**CALIFORNIA COASTAL COMMISSION**

**5-18-0976 (SILVERS)**

**JUNE 14, 2019**

**EXHIBITS**

**Exhibit No. 4 – Changes to the project to be consistent with the City of Newport Beach Harbor Design Criteria Guidelines and Standards**

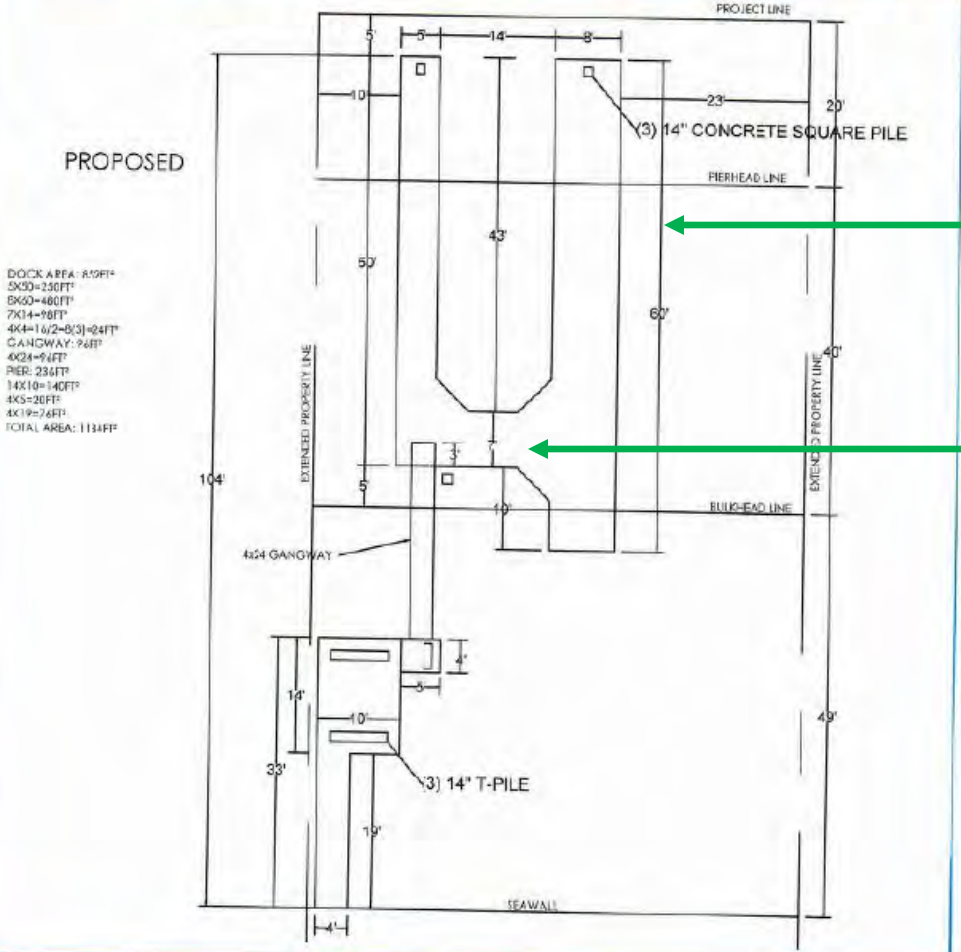
*Proposed 8-foot wide finger should be reduced to 5-foot wide*

*Proposed 7-foot wide headwalk should be reduced to 6-foot wide*

**Exhibit No. 5 – Site Plan indicating Eelgrass Impacts**

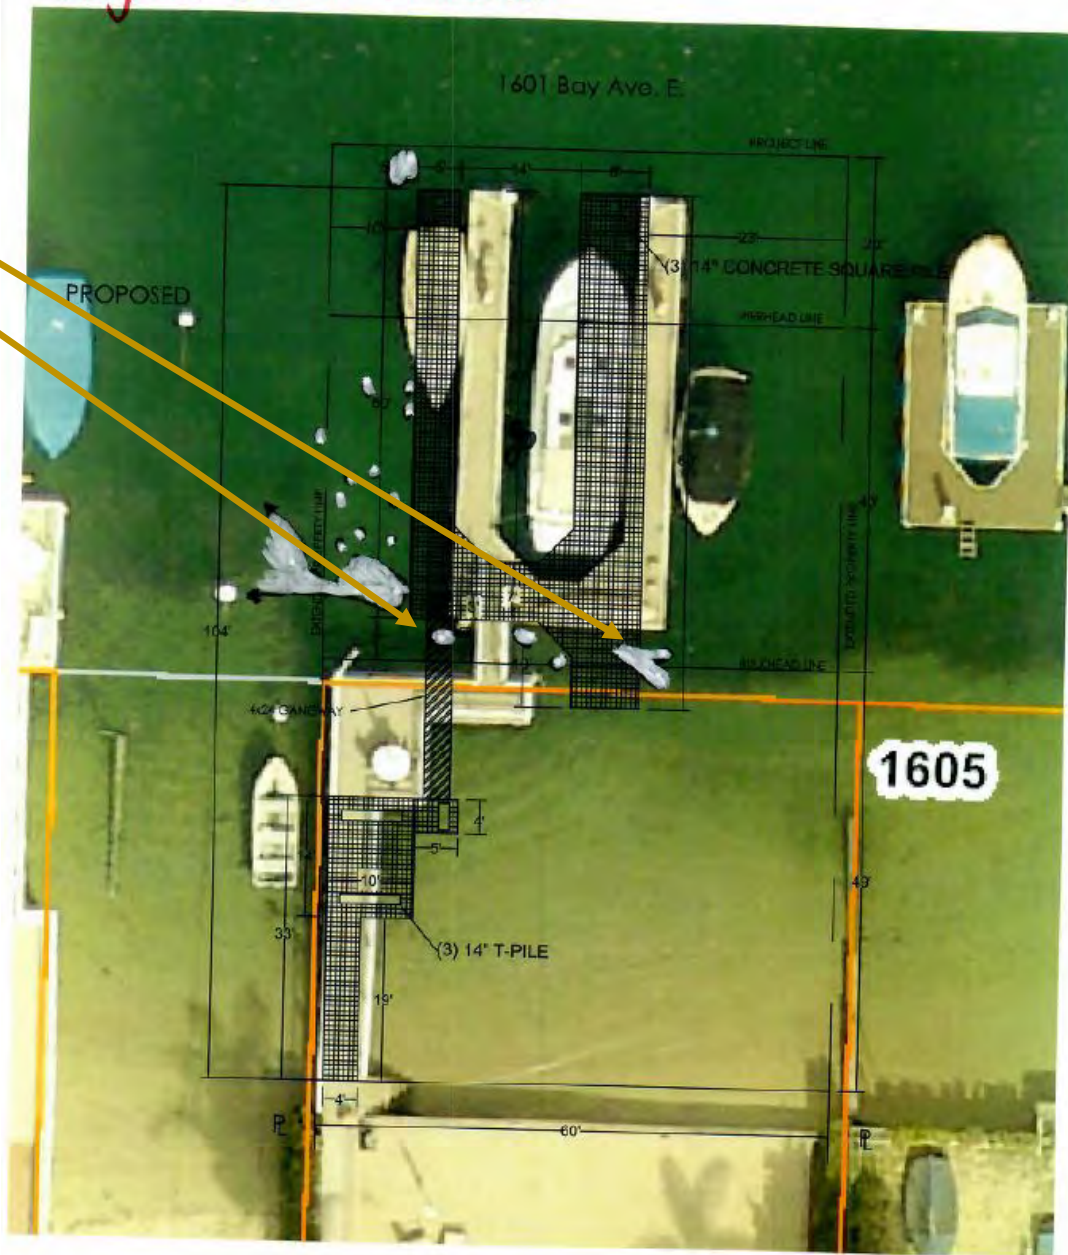
*Eelgrass shown in white*

*Eelgrass shading impacts*
